APPLICATION NO.	FILING DATE	FIRST NAMED INVENTOR	ATTORNEY DOCKET NO.	CONFIRMATION NO.
10/677,282	10/03/2003	Noritaka Okuda	3718-0105P	9656
2292 7590 08/16/2007 BIRCH STEWART KOLASCH & BIRCH PO BOX 747 FALLS CHURCH, VA 22040-0747			EXAMINER CHENG, PETER L	
			ART UNIT 2625	PAPER NUMBER
			NOTIFICATION DATE 08/16/2007	DELIVERY MODE ELECTRONIC

Office Action Summary	Application No. 10/677,282	Applicant(s) OKUDA ET AL.	
	Examiner Peter L. Cheng	Art Unit 2625

DETAILED ACTION

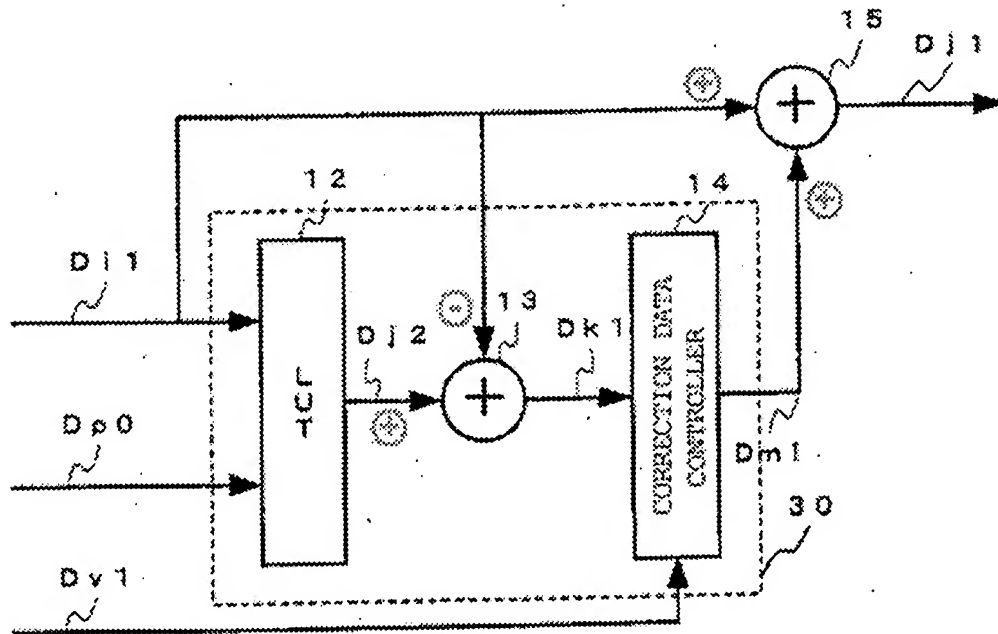
- **Fig. 1:** the specification [e.g., **page 6, lines 21, 29**] refers to the "Frame Data Correction Device" as reference number **3**; the specification [e.g., **page 5, line 4**]a/ so refers to the "Frame Data Correction Device" as reference number **10**;

Fig. 1 cites, **10 FRAME DATA CORRECTION DEVICE**; if applicant intended to associate reference number **3** with the "Frame Data Correction Device", the citation should be changed to **3 FRAME DATA CORRECTION DEVICE**;

*However, for the purpose of claim interpretation, it is assumed that applicant intended to cite reference number **10** as the "frame data correction device" comprising a "correction data output device" (reference number **30**).*

Fig. 11

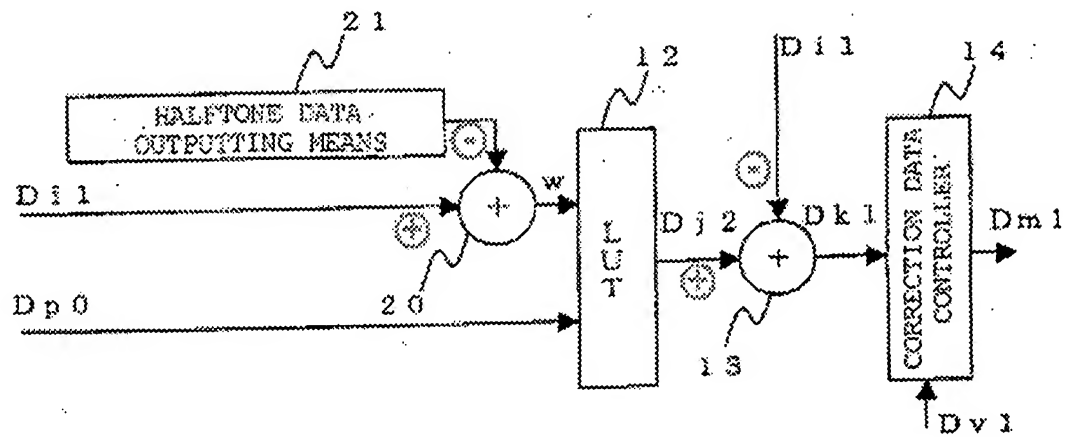
- **Fig. 11:** the specification defines "w" as being equal to "Di1" minus the "halftone data"; "The subtracter 20 subtracts the ... halftone data from the ... object frame data Di1 and outputs a signal ... referred to as a gray-level signal w"; **page 17, lines 23 – 27;**

similarly, suggest adding "polarity signs" at adders 13 and 20 as shown below:

Fig. 13

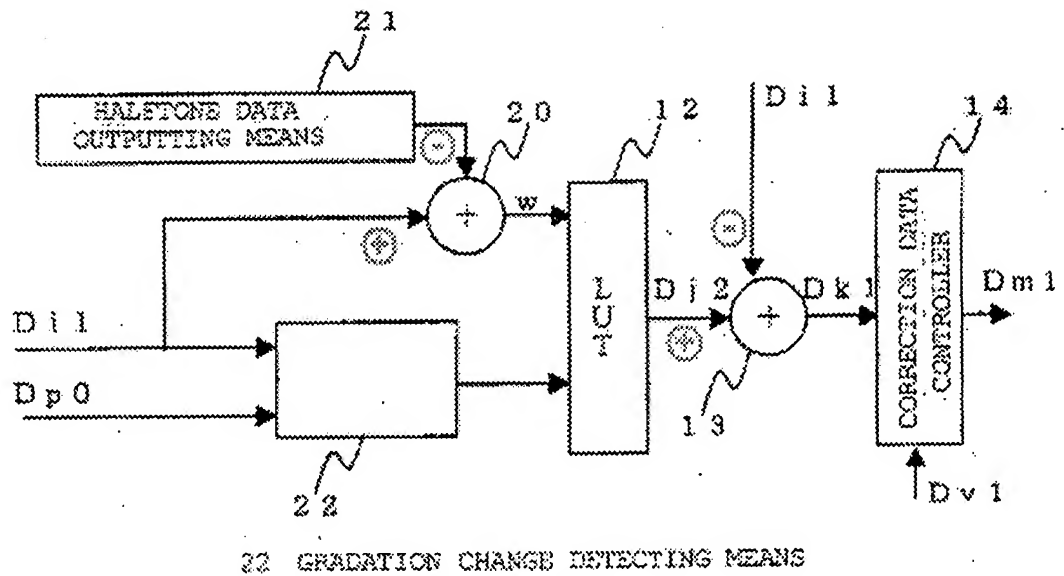
- **Fig. 13:** similarly, suggest adding "polarity signs" at adders 13 and 20 as shown below:

Fig. 17

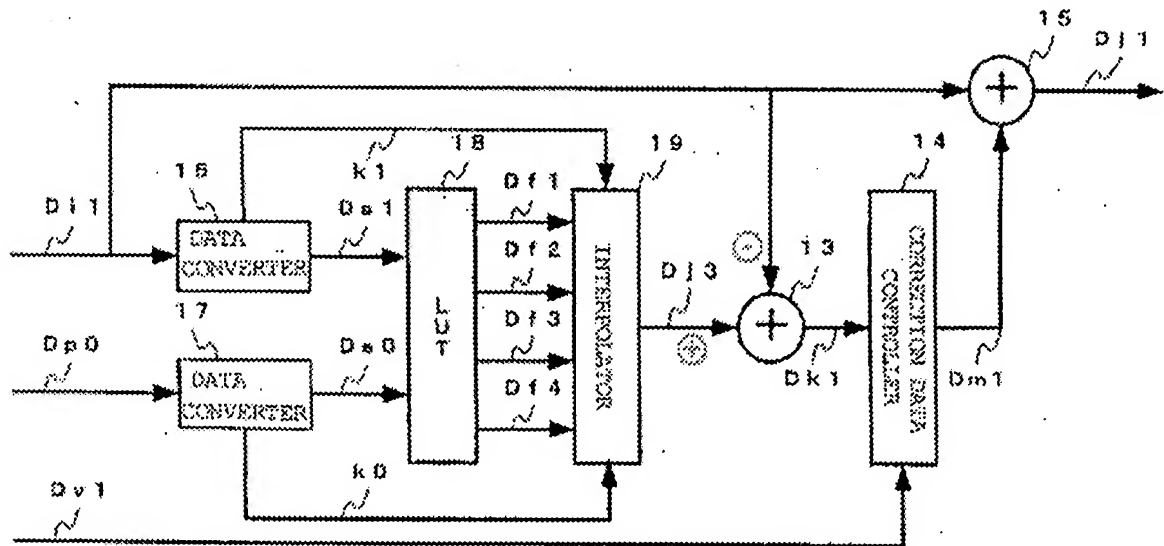
- **Fig. 17:** similarly, suggest adding "polarity signs" at adder 13 as shown below:

2. The drawings are objected to as failing to comply with 37 CFR 1.84(p)(5) because they do not include the following reference sign(s) mentioned in the description: **Fig. 17** reference number **31** (correction data output device) as cited on **page 24, lines 18, 22, 29** and **page 25, lines 1 - 2**. Corrected drawing sheets in compliance with 37 CFR 1.121(d) are required in reply to the Office action to avoid abandonment of the application. Any amended replacement drawing sheet should include all of the figures appearing on the immediate prior version of the sheet, even if only one figure is being amended. Each drawing sheet submitted after the filing date of an application must be labeled in the top margin as either "Replacement Sheet" or "New Sheet" pursuant to 37 CFR 1.121(d). If the changes are not accepted by the examiner,
